SUNDRY NOTICES AND REPORTS ON WELLS

8. Well Name and No.
COTTON DRAW 14 FED COM 2H

TYPE OF SUBMISSION	TYPE OF ACTION			
☒ Notice of Intent	☐ Acidize	☐ Deepen	☐ Production (Start/Resume)	☐ Water Shut-Off
☐ Subsequent Report	☐ Alter Casing	☐ Fracture Treat	☐ Reclamation	☐ Well Integrity
☐ Final Abandonment Notice	☐ Casing Repair	☐ New Construction	☐ Recomplete	☒ Other Change to Original APD
	☐ Change Plans	☐ Plug and Abandon	☐ Temporarily Abandon	
	☐ Convert to Injection	☐ Plug Back	☐ Water Disposal

PECOS DISTRICT
CONDITIONS OF APPROVAL

DRAWING NUMBER
DM100161771-2A

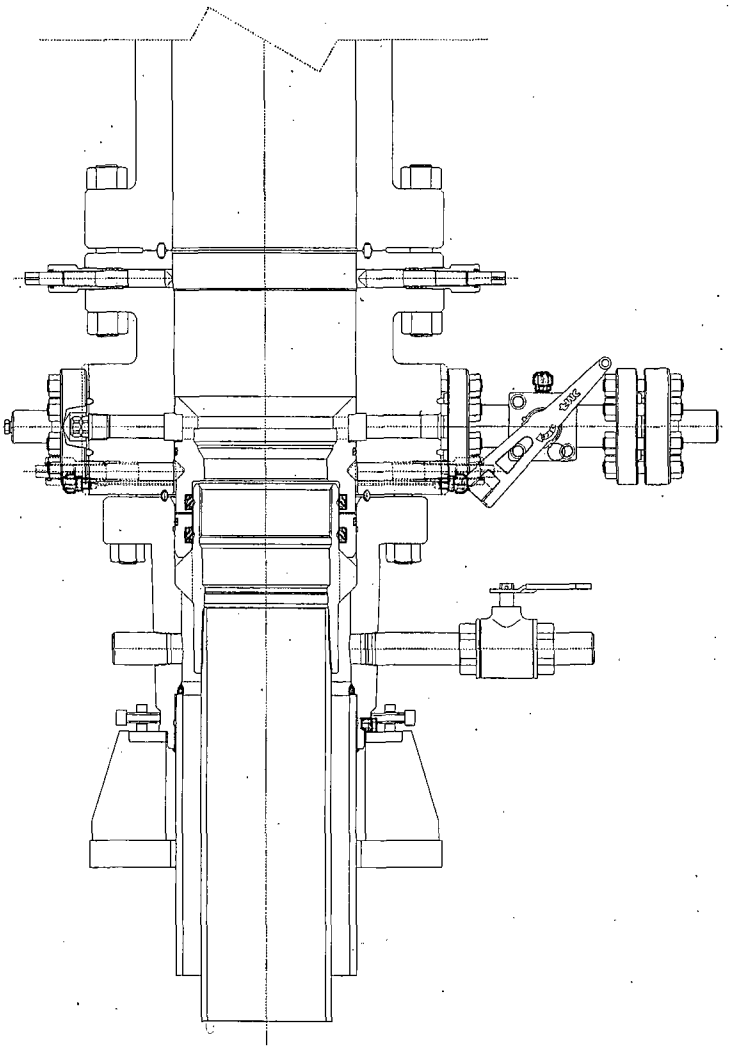
Devon Energy Production Company, L.P. respectfully proposes using a multi-bowl wellhead assembly (FMC Uni-head). This assembly will only be tested when installed on the surface casing. Minimum working pressure of the blowout preventer (BOP) and related equipment (BOPE) required for drilling below the surface casing shoe shall be 5000 (5M) psi.

* Wellhead will be installed by FMC's representatives.
* If the welding is performed by a third party, the FMC's representative will monitor the temperature to verify that it does not exceed the maximum temperature of the seal.

* FMC representative will install the test plug for the initial BOP test.
* FMC will install a solid steel body pack-off to completely isolate the lower head after cementing intermediate casing. After installation of the pack-off, the pack-off and the lower flange will be tested to 5M, as shown on the attached schematic. Everything above the pack-off will not have been altered whatsoever from the initial nipple up. Therefore the BOP components will not be retested at

After running the 9-5/8' intermediate casing with a mandrel hanger, the 13-5/8" BOP/BOPE system with a minimum rating of 5M will already be installed on the FMC Uni-head. Please find attached the wellhead schematic.

3. **Operator has proposed a multi-bowl wellhead assembly. This assembly will only be tested when installed on the surface casing. Minimum working pressure of the blowout preventer (BOP) and related equipment (BOPE) required for drilling below the surface casing shoe shall be 5000 (5M) psi.**

a. **Wellhead shall be installed by manufacturer's representatives, submit documentation with subsequent sundry.**
    b. **If the welding is performed by a third party, the manufacturer's representative shall monitor the temperature to verify that it does not exceed the maximum temperature of the seal.**
    c. **Manufacturer representative shall install the test plug for the initial BOP test.**
    d. **Operator shall perform the intermediate casing integrity test to 70% of the casing burst. This will test the multi-bowl seals.**
    e. **If the cement does not circulate and one inch operations would have been possible with a standard wellhead, the well head shall be cut off, cementing operations performed and another wellhead installed.**
